Re: **Second Submission Review** – Porteos Infrastructure Site Plan Phase 7
Application Number: **DA-1903-16**
Case Number: **2020-6005-00**

Second Submission Review

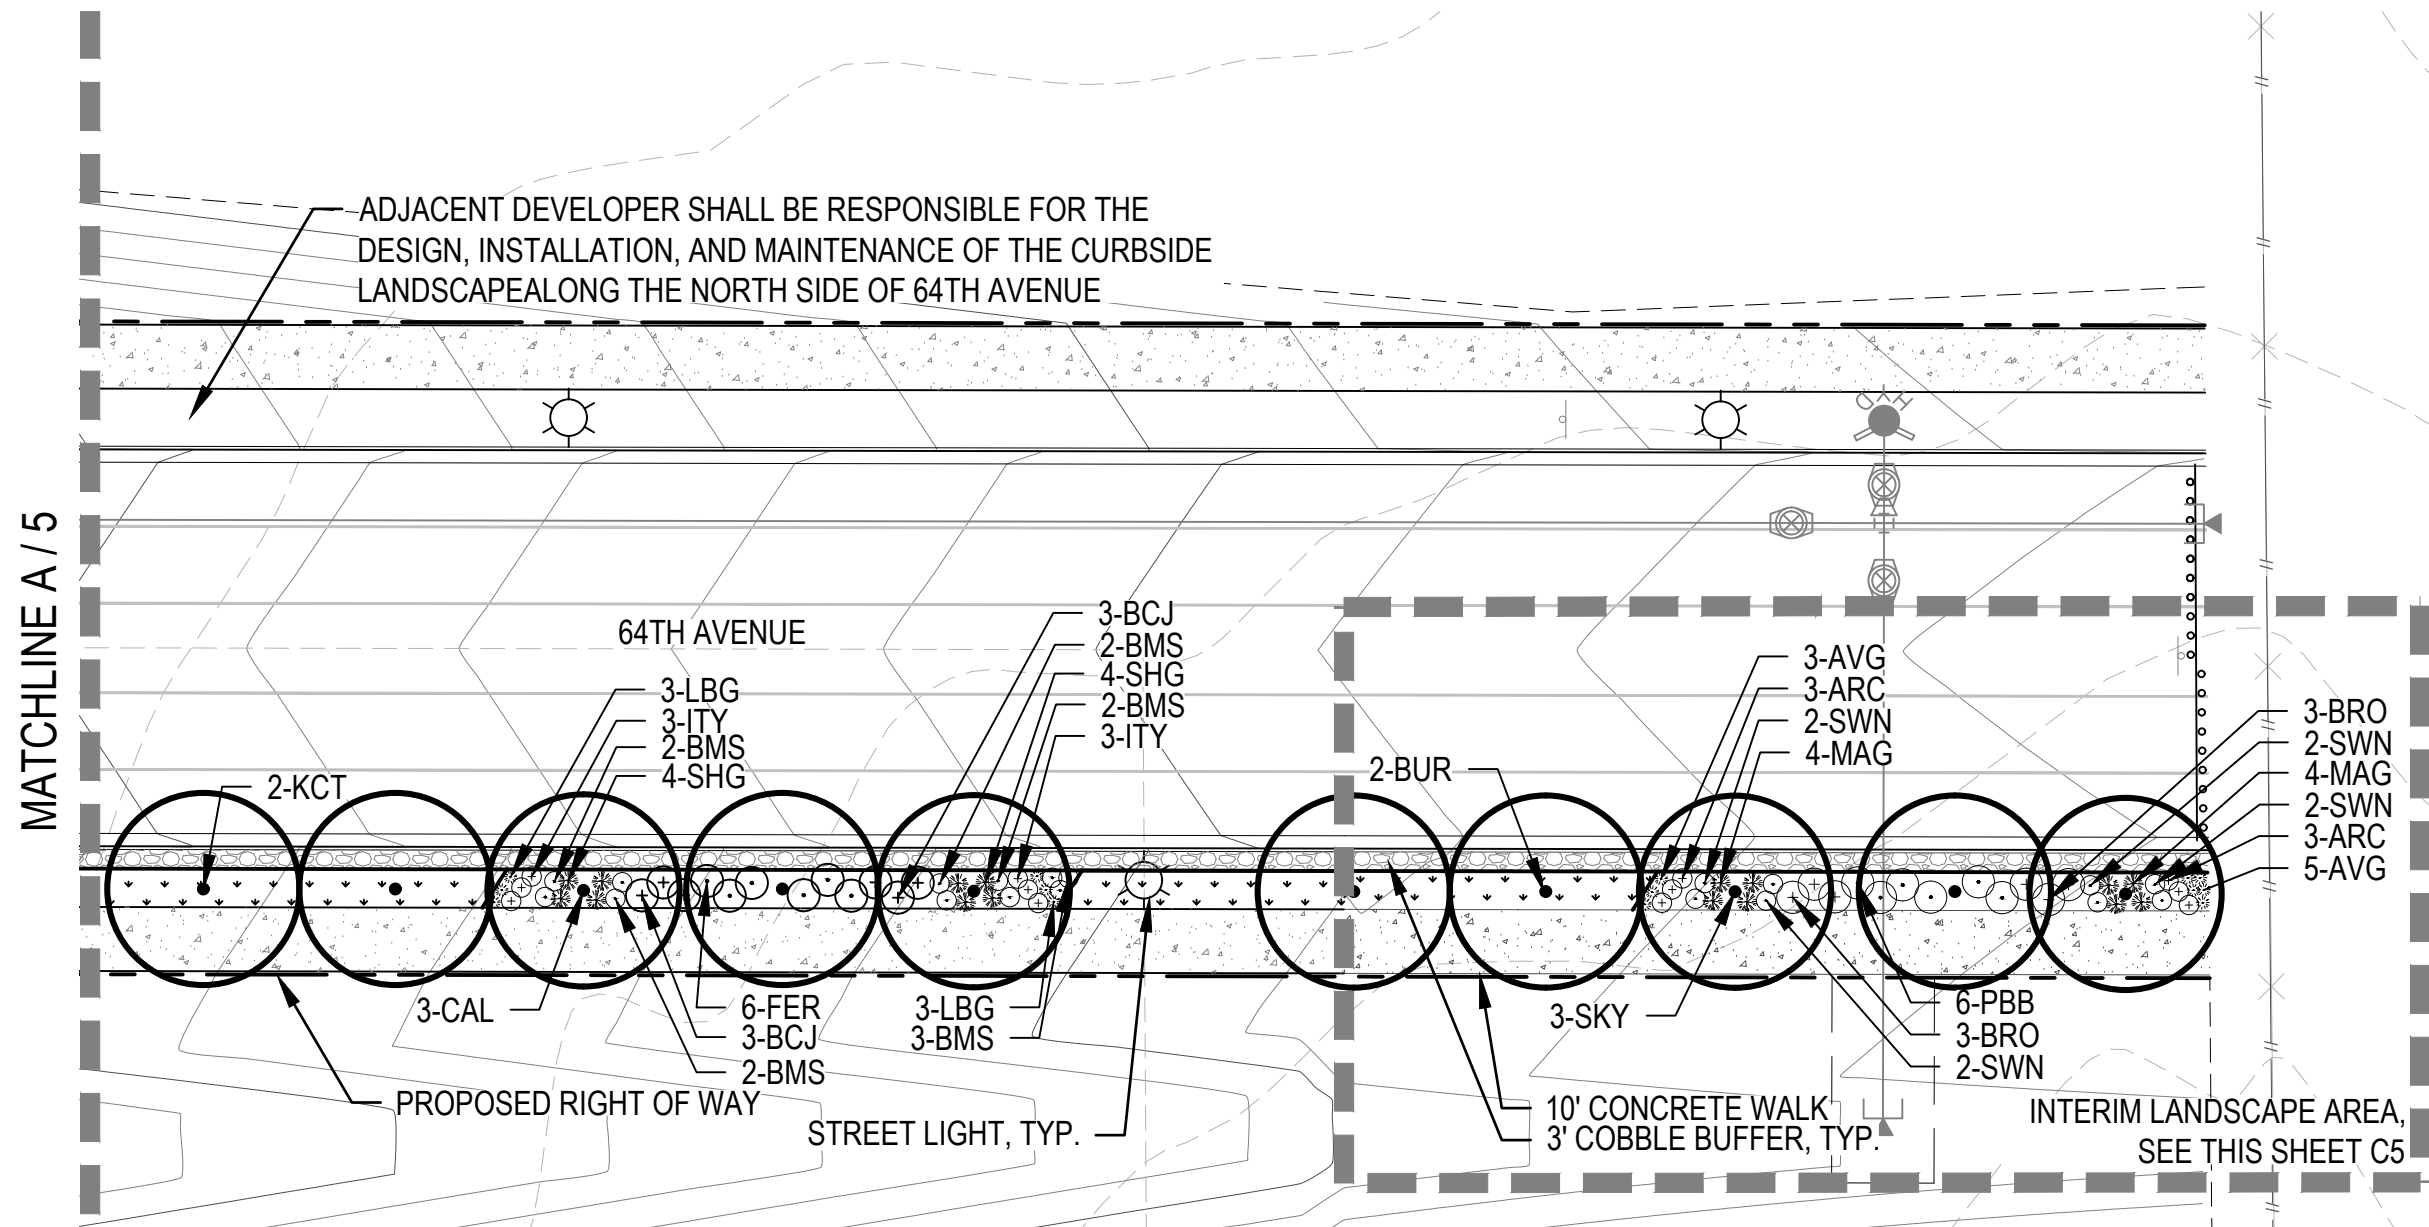
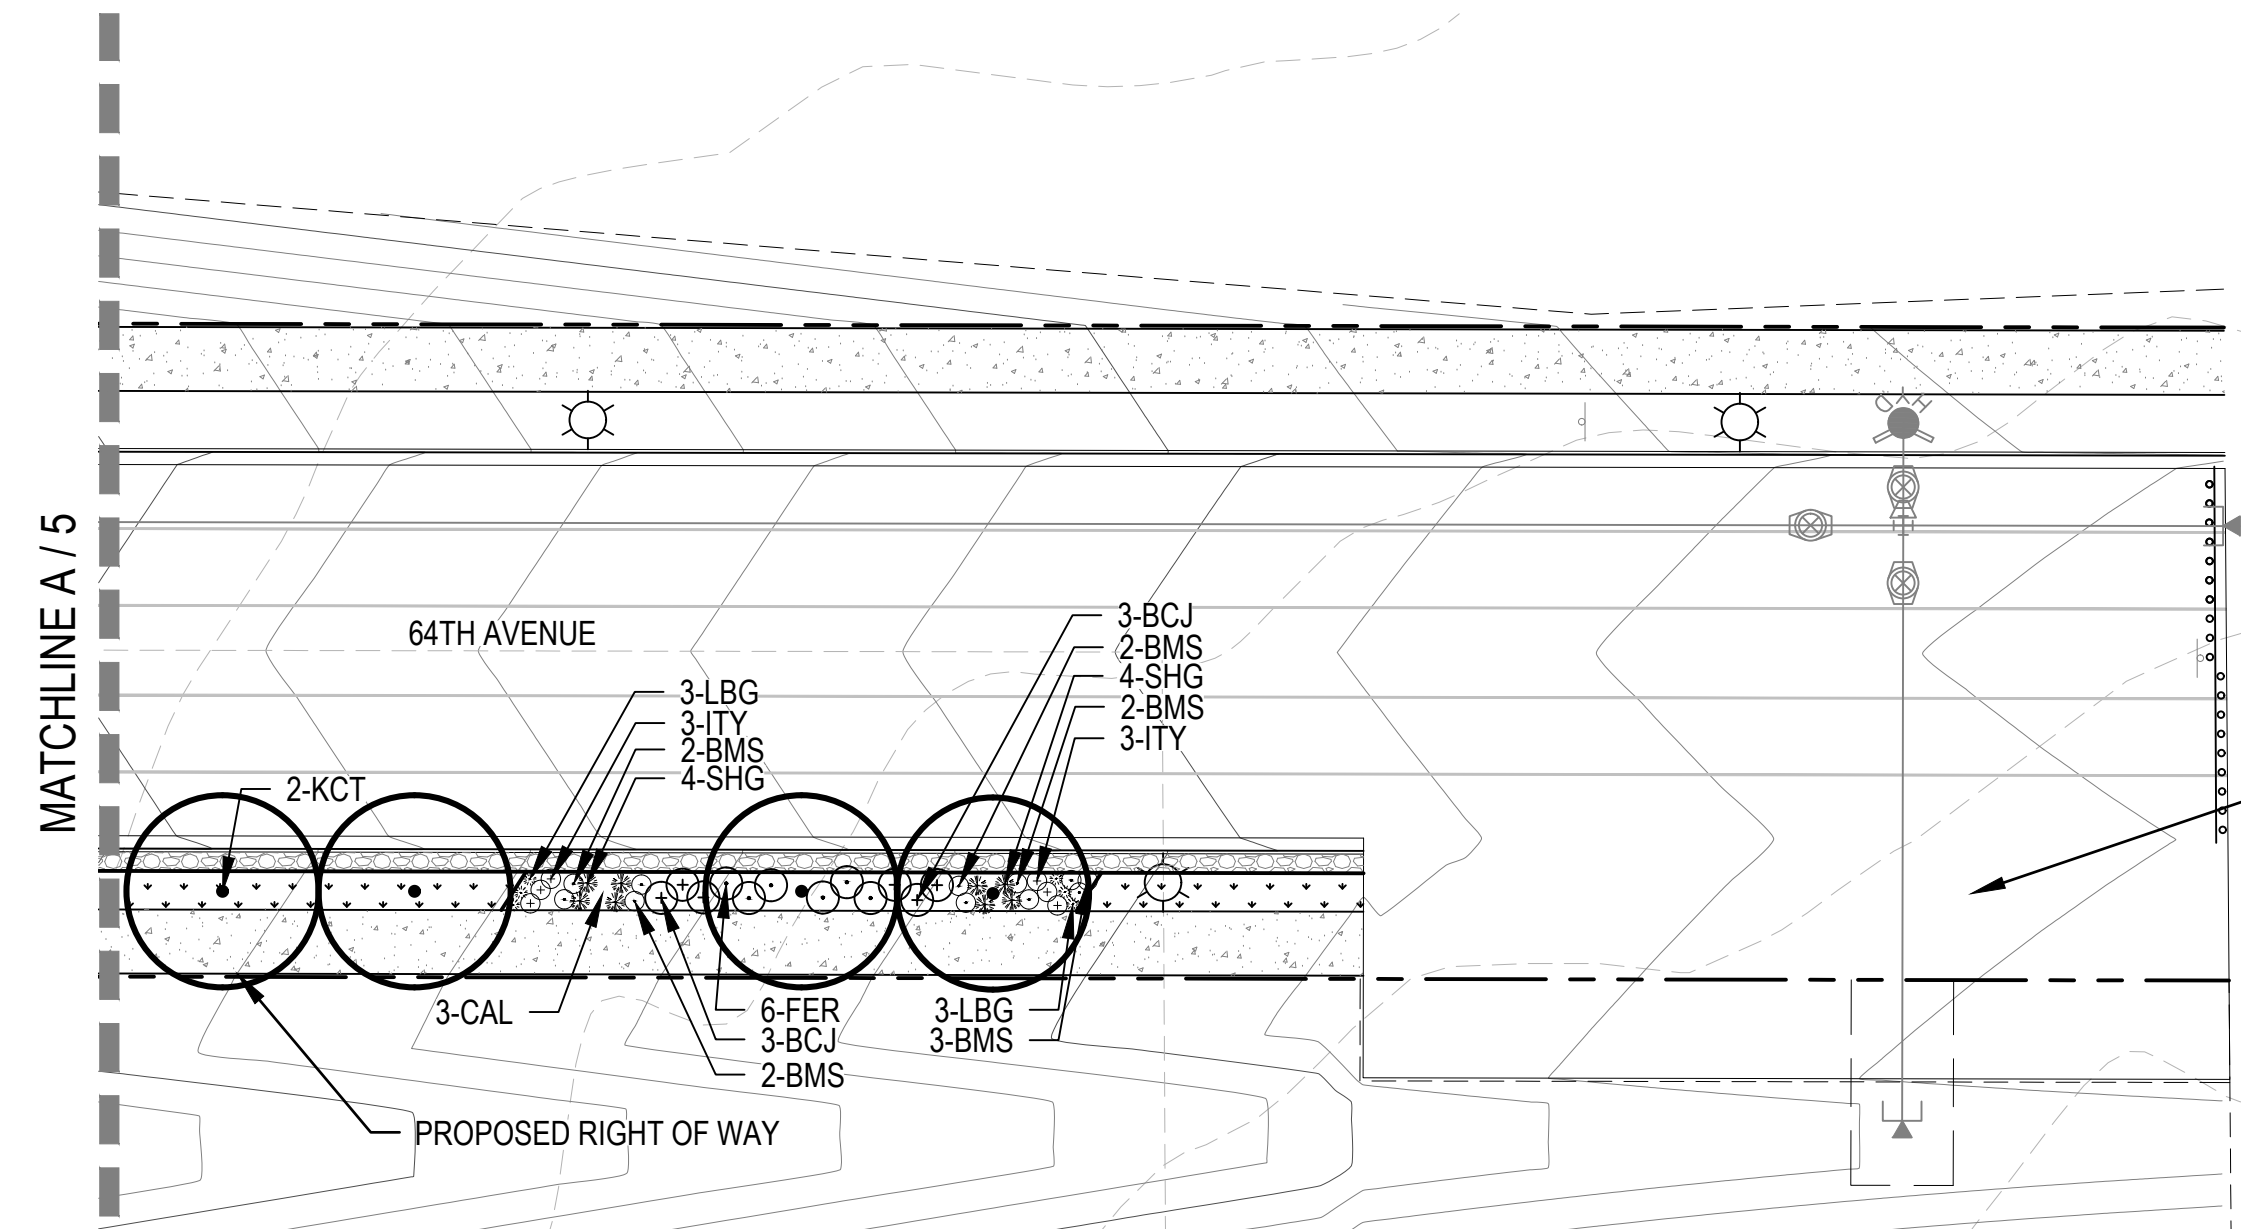
2E. Sheet 9: Modify note to read: "the ultimate landscape condition i.e. the remaining trees and shrubs that are deficient due to the public/life safety turn around shall be installed by the metro district once the turnaround is removed". This portion of the missing streetscape is no different than the stretch directly to the west of it. It is all metro district controlled.

This should read that the "ultimate landscape condition i.e. the remaining trees and shrubs that are deficient due to the public/life safety turn around shall be installed by the metro district once the turn around is removed". This portion of the missing streetscape is no different than the stretch directly to the west of it. It is all metro district controlled.

Response: Note has been revised per comment.

Response:
Note has been revised.
